# **Springbank Off-stream Reservoir (SR1)**

NRCB Hearing: Topic 1  
Summary of Exhibits 253, 254

Karin Hunter, BCom Finance, CFA  
On behalf of the Springbank Concerned  
Landowners Group (SCLG)

Source: Deltares Report (2015) <sup>(1)</sup>

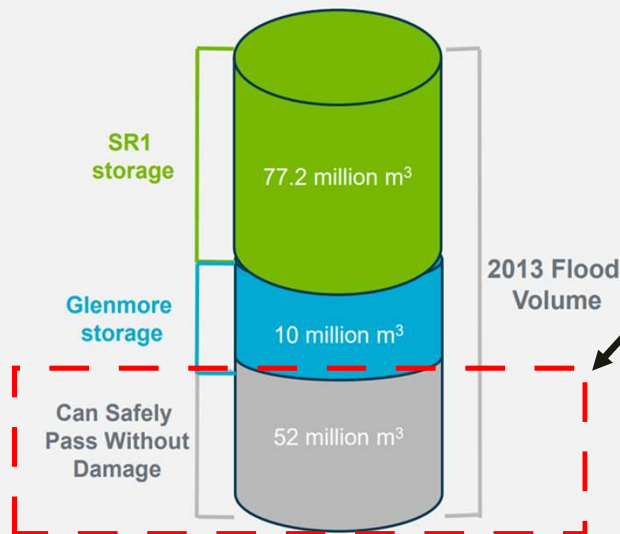
- This is blatantly untrue
- It appears that NO comparison of SR1 and MC1 flood rate analysis was performed
- Using the Proponent's own data, it is clear that MC1 has superior flood reduction capabilities across a range of flood scenarios with the added benefit of its location which protects more communities
